N3382A-02

S E R V I C E N O T E

N3382A PNA Microwave Network Analyzers

Figure 1: A3 Front Panel Interface Board Assy without the Bracket

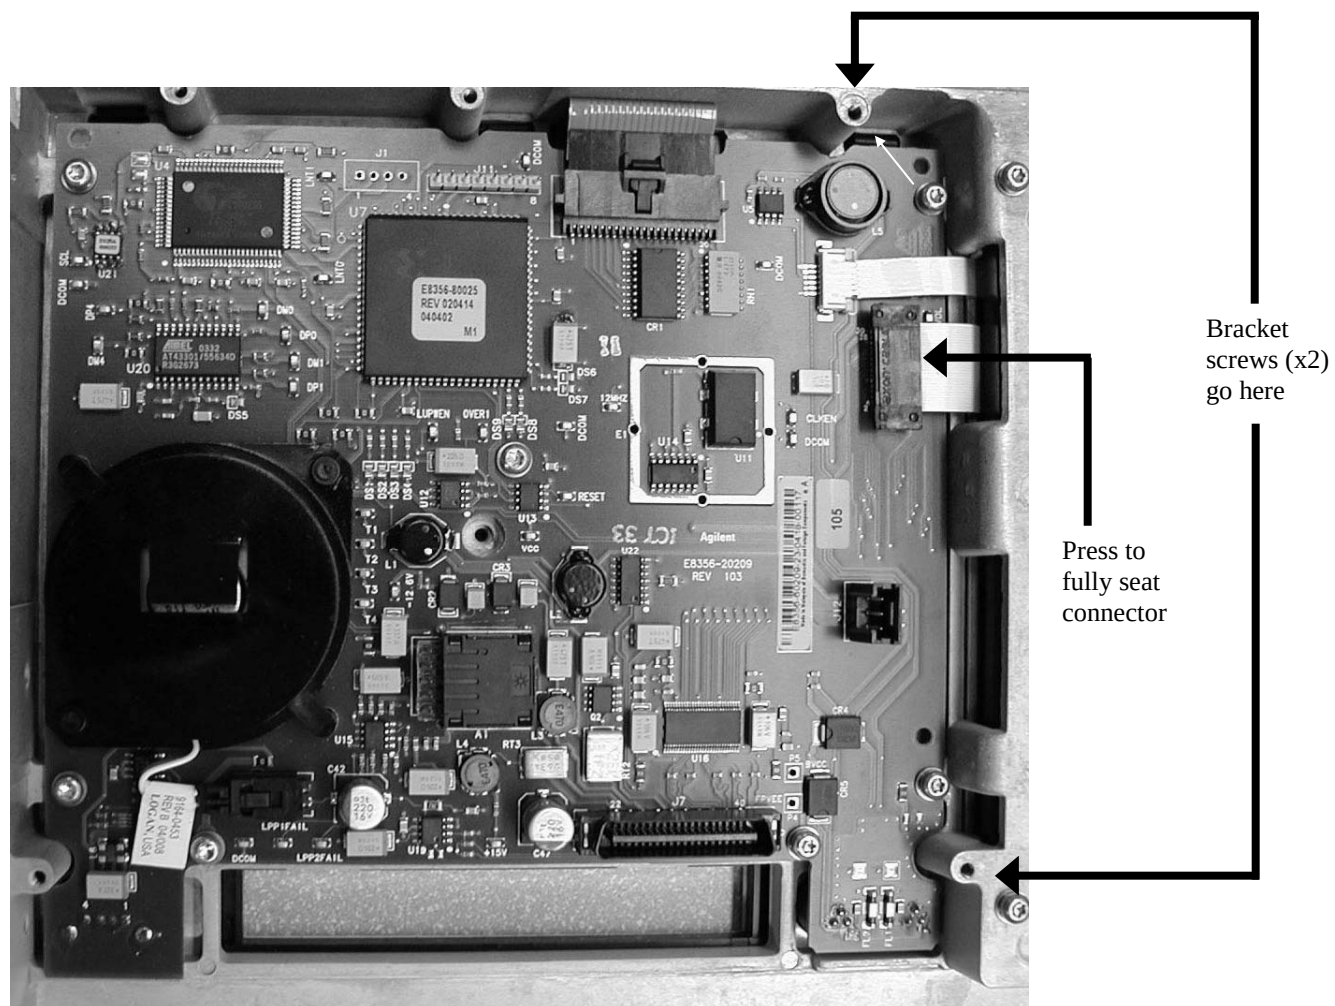
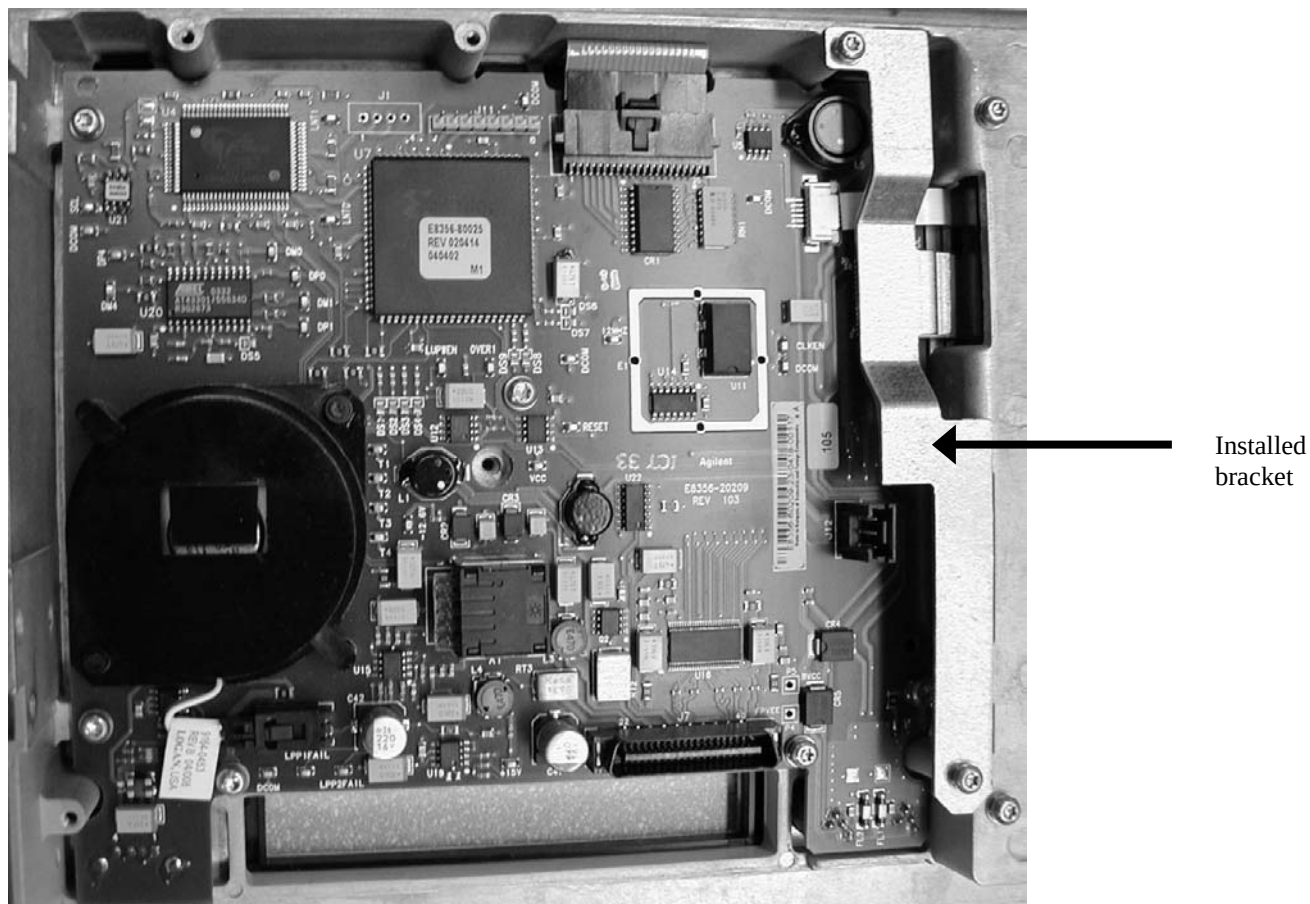
A connector of the ribbon cable (Agilent part number 8120-8409) that joins the front panel display to the front panel interface board can loosen, causing a display failure, unless a new bracket is installed. Because the failure rate has been very low, it is recommended that the bracket be installed only when there is an additional reason to remove the PNA front panel.

1. Refer to Figure 1 in this document:
 - Press down firmly on the ribbon cable's black connector.
 - Locate the two tapped holes for the bracket screws.
2. As shown in Figure 2 in this document, position the bracket so that its holes line-up with the two holes you located in the previous step.
3. Hand-start the two screws, and then torque both to 9 in-lbs.
4. Reinstall the PNA Front Panel by following the Service Guide instructions in the "Replacement Procedure." This is located on the same page as the "Removal Procedure" used previously in step 7.
